Access Compliance Report

Public Rights-of-Way

Intersection ID: 3984	Main Street: GENOA_LN	Cross Street: HALLIWELL_ST	Location: W
ADA ID: 8B3E8E80378D	Ramp Type: Perp	Initial Pass/Fail: Fail	Overall Compliance: No
		Severity Score: 25

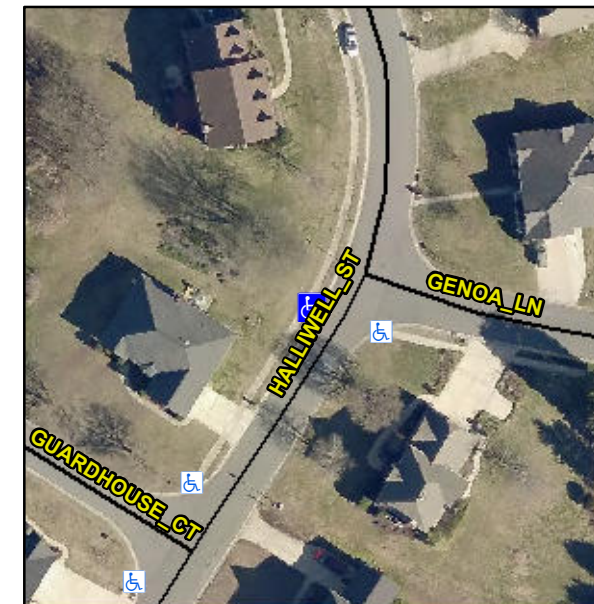
Not Found, R304.5.3

Compliance	Description	Data	Compliance	Description	Data
N/A	Ramp Length (in)	45.0	Yes	Ramp Slope (%)	5.0
Yes	Ramp Width (in)	88.0	No	Ramp XSlope (%)	10.0
N/A	Flare Type LT	N/A	N/A	Flare Type RT	N/A
N/A	Flare Slope LT (%)	N/A	N/A	Flare Slope RT (%)	N/A
N/A	Flare Traversable LT?	N/A	N/A	Flare Traversable RT?	N/A
N/A	Landing Length (in)	N/A	N/A	DWS Provided?	N/A
N/A	Landing Width (in)	N/A	N/A	DWS Contrast?	N/A
N/A	Landing Slope (%)	N/A	N/A	DWS Length (in)	N/A
N/A	Landing X Slope (%)	N/A	N/A	DWS Full Width?	N/A
N/A	Landing Curb? (Y/N)	N/A	N/A	DWS Offset (in)	N/A
N/A	Shared Landing?	N/A			
N/A	Gutter Ponding?	N/A	N/A	Gutter Slope (%)	N/A
N/A	Gutter Lip Ht (in)	N/A	N/A	Gutter X Slope (%)	N/A
N/A	Painted X Walk1?	No	N/A	Painted X Walk2?	N/A
	X Walk 1 Direction	To SE		X Walk 2 Direction	N/A
N/A	X Walk 1 Width (in)	N/A	N/A	X Walk 2 Width (in)	N/A
	X Walk 1 Slope (%)	6.2		X Walk 2 Slope (%)	N/A
	X Walk 1 X Slope (%)	11.9		X Walk 2 X Slope (%)	N/A

Remove & Replace Entire Ramp.
